Re: 66-Inch Sewer IRM Remedial Design
New York State Electric & Gas Corporation
Court Street Site
Binghamton, New York
BBL Project #: 0130.13041 #2

This letter has been prepared on behalf of New York State Electric & Gas Corporation (NYSEG) in response to your October 4, 2002 comment letter on the Draft Work Plan for Conducting an Interim Remedial Measure (Work Plan) at the Court Street Site located in Binghamton, New York (BBL, September 2002). This letter has also been prepared based on the New York State Department of Environmental Conservation's (NYSDEC's) November 5, 2002 telephone conversations with NYSEG. Presented below are NYSDEC's comments on the Work Plan followed by NYSEG's responses to the NYSDEC's comments. For ease of review, the NYSDEC's comments are presented in italic font.

Remedial Design for 66-Inch Storm Sewer IRM

TOMPKINS STREET
STORM PUMPING STATION

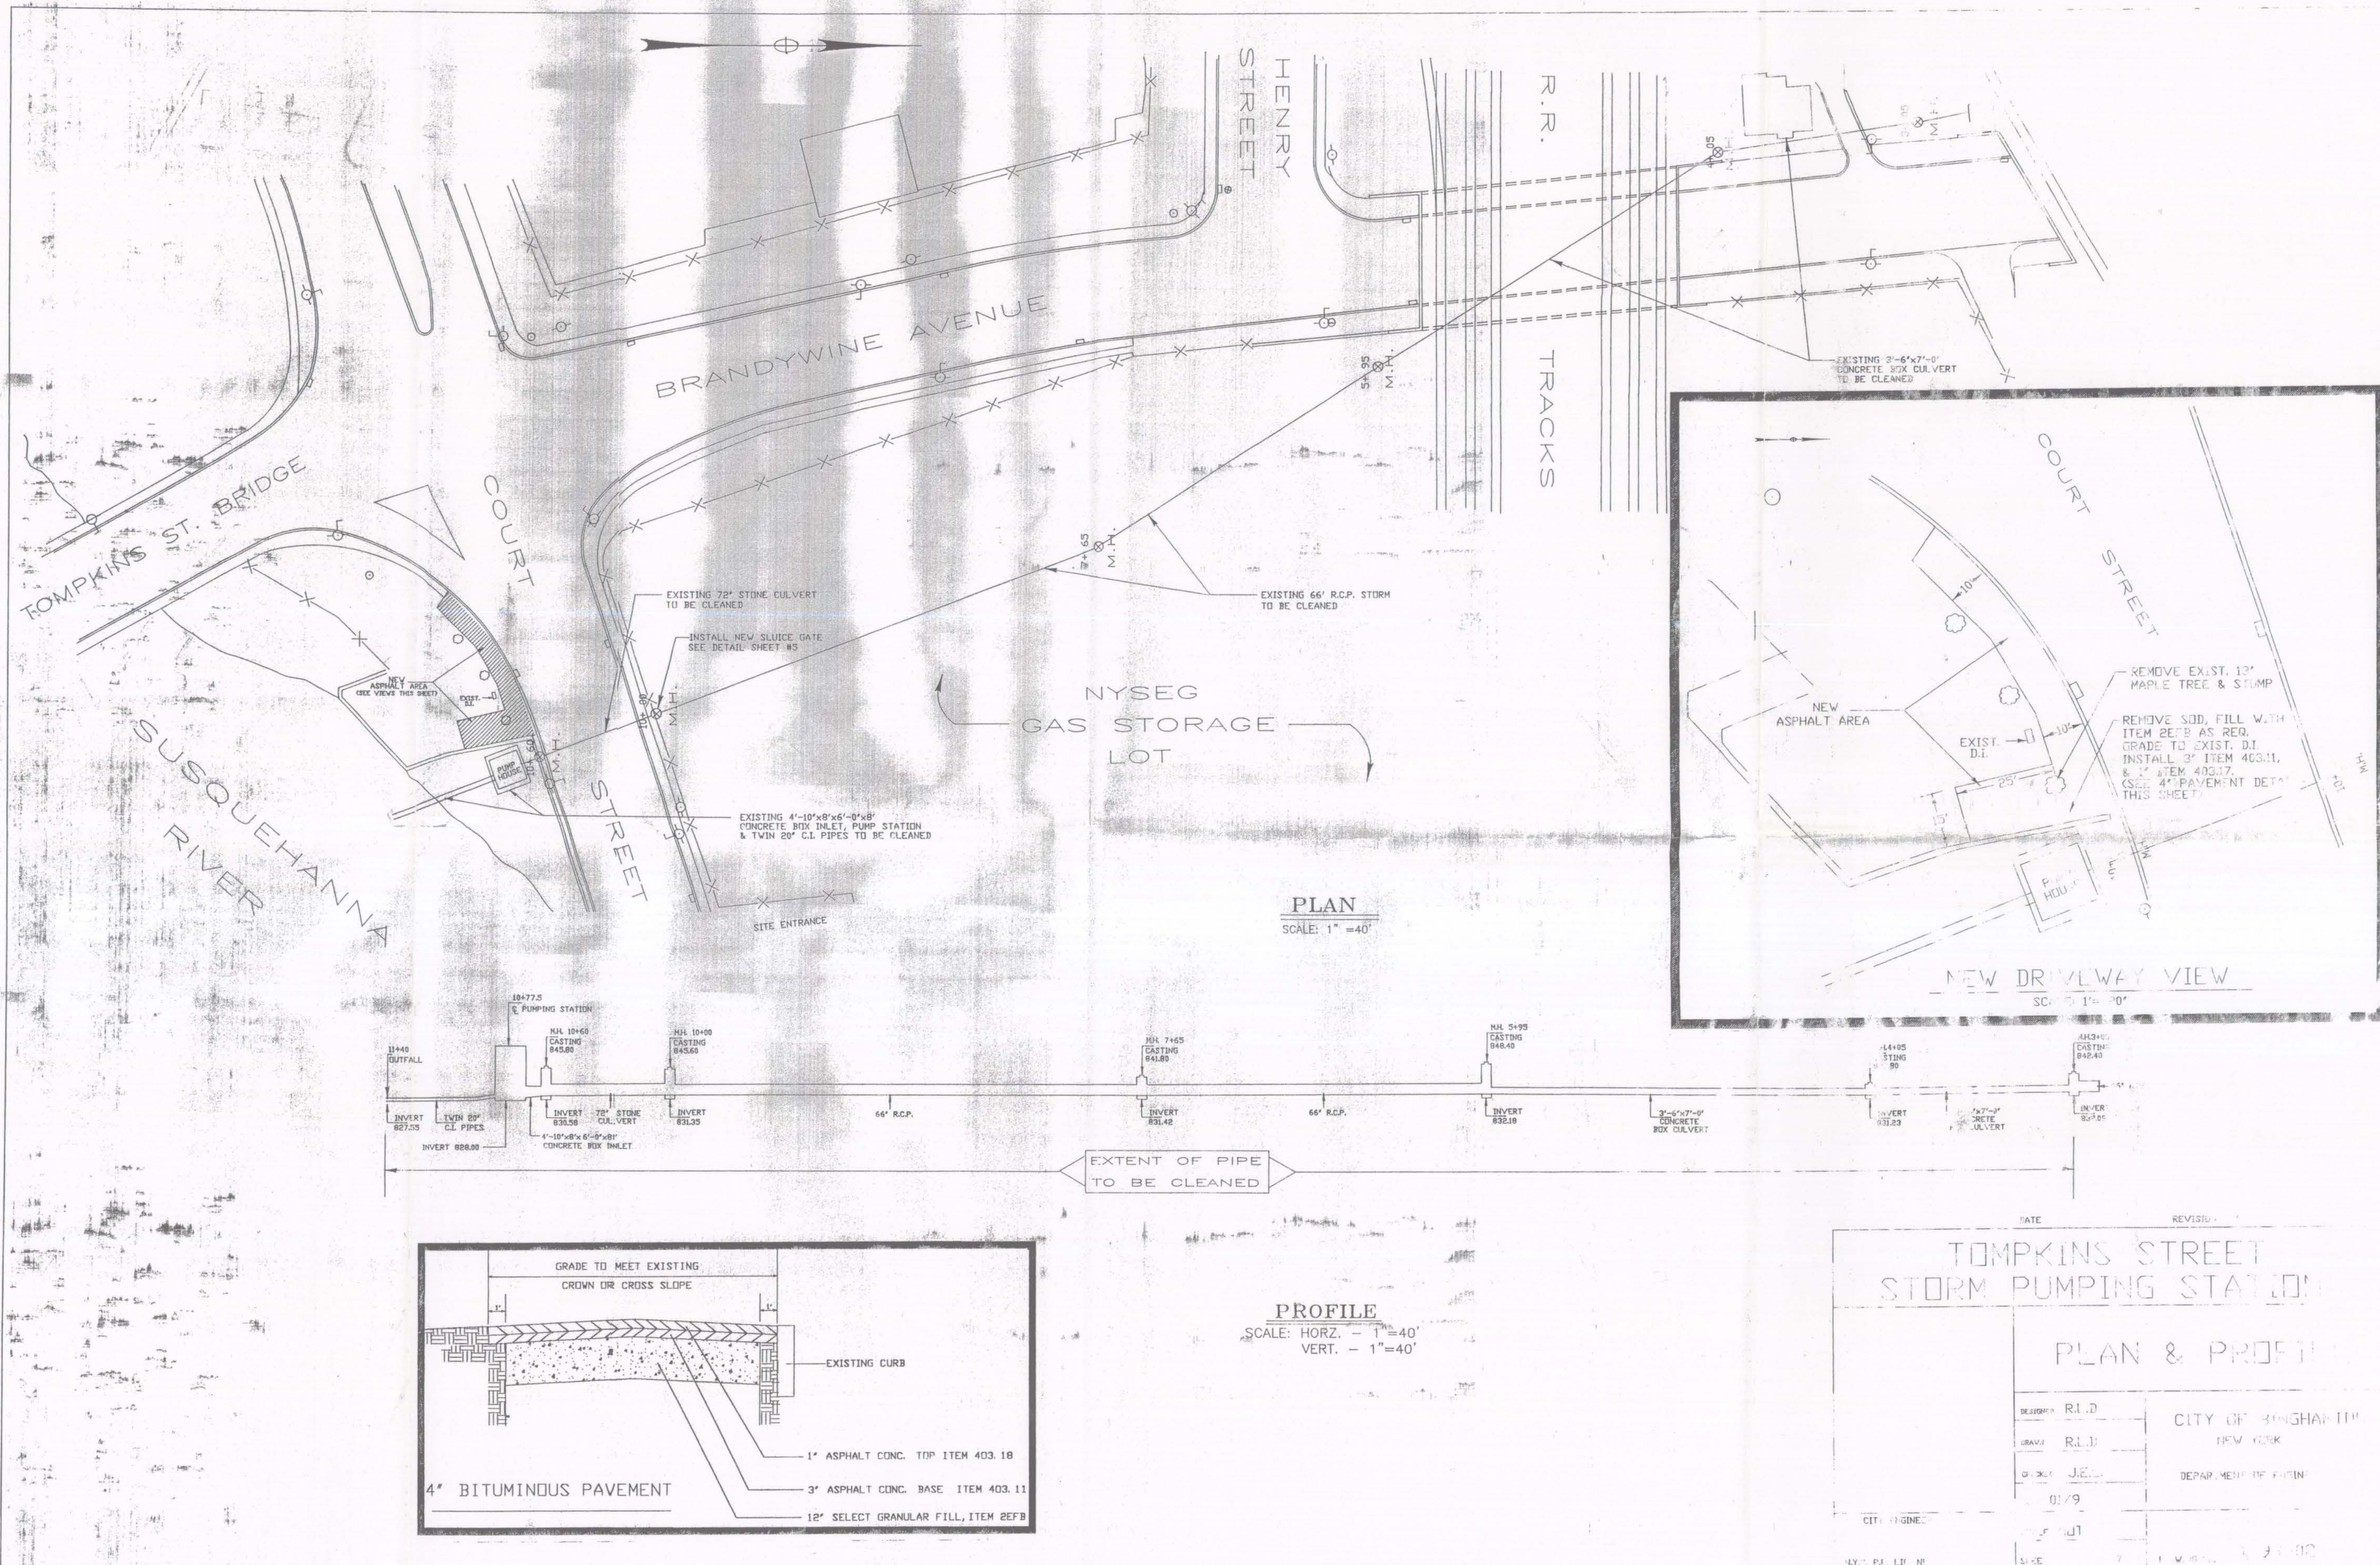
Please provide to the DEC, copies of the City of Binghamton Engineering Drawings for the Tompkins Street Storm Pumping Station.

A copy of the Engineering Drawings provided by the City of Binghamton for the Tompkins Street Pump Station is attached.
